In the Drawings

REMARKS

FIG. 2

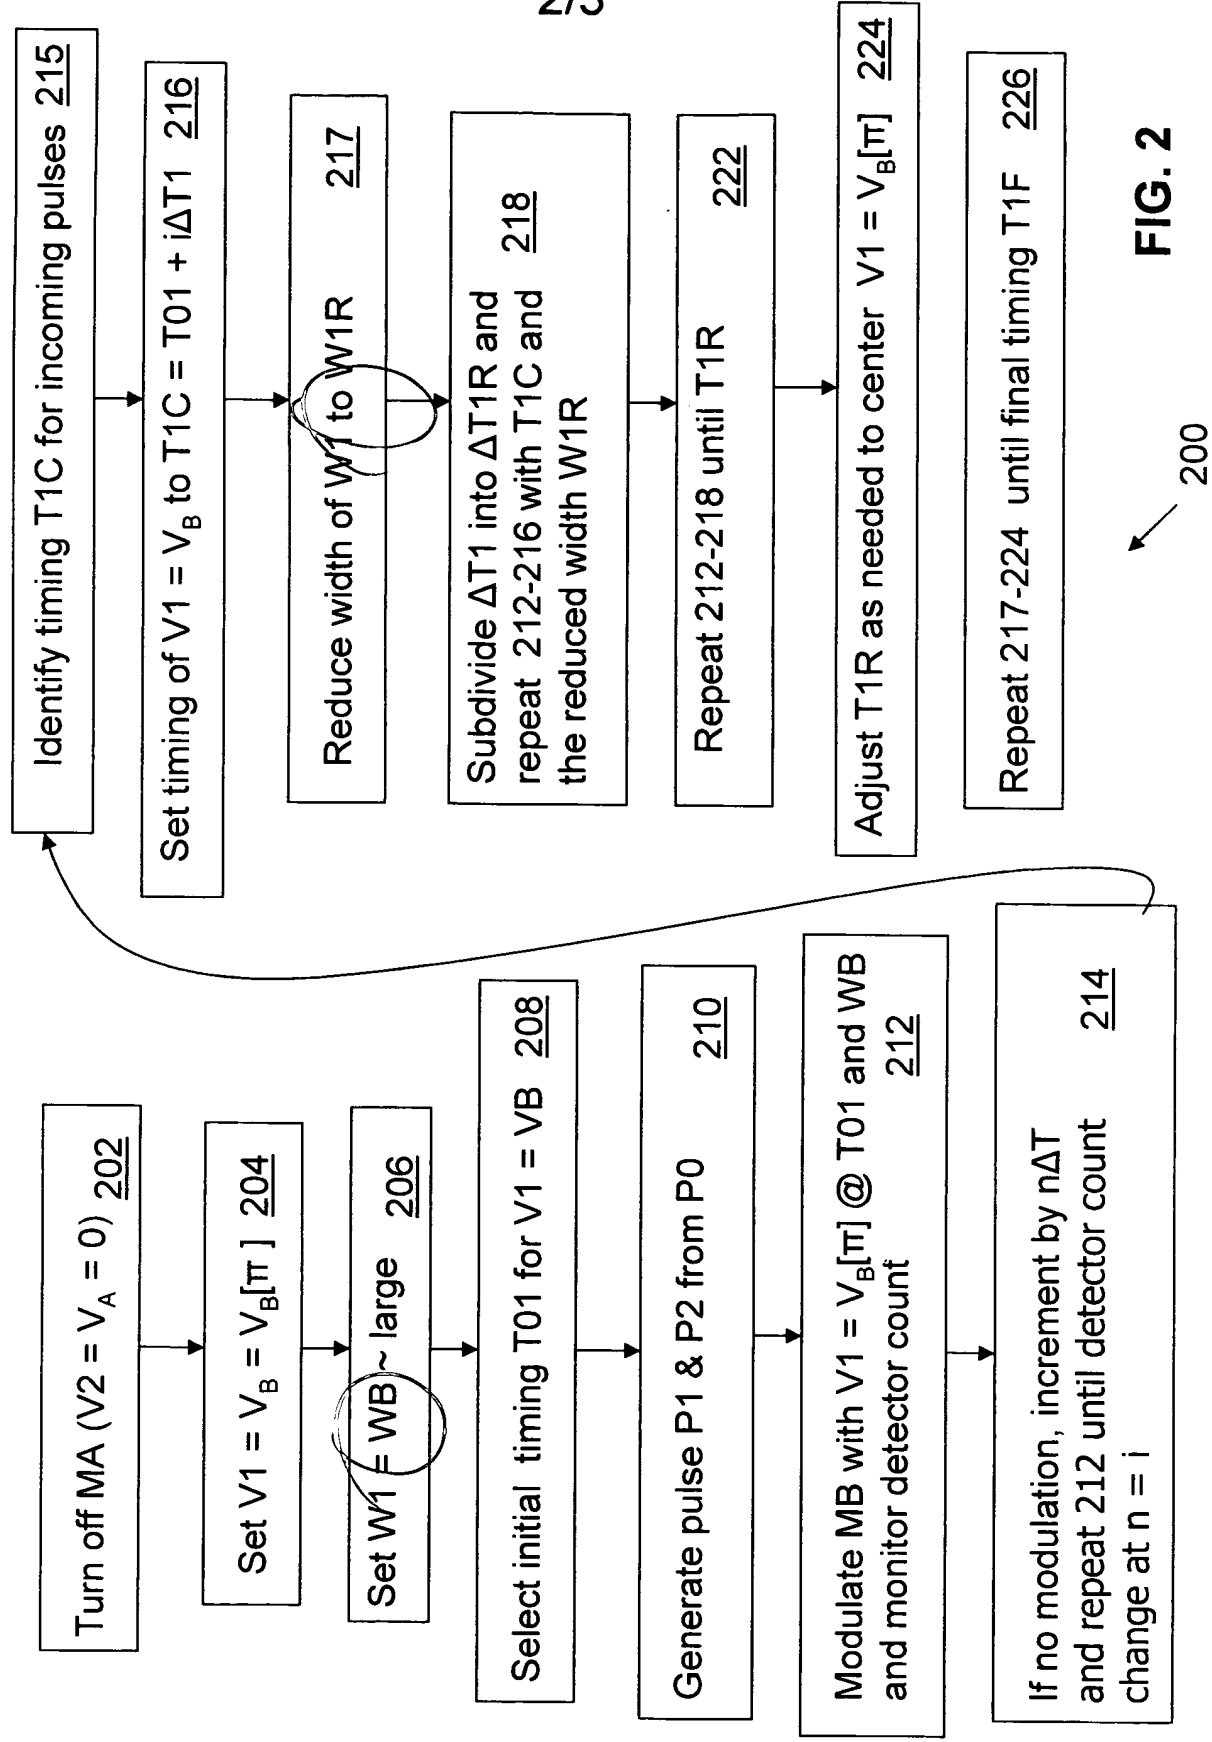
FIGS. 2 and 3 were amended to make certain sections of the flow diagram more consistent with the language of the specification, particularly as set forth on pages 7-11 for FIG. 2 and pages 11-13 for FIG. 3, in connection with activation signal widths W1 and W2 and the “coarse” values of $W1 = W1C$ and $W2 = W2C$. Replacement sheets for FIGS. 2 and 3 are provided, along with annotated sheets indicating the changes in red.
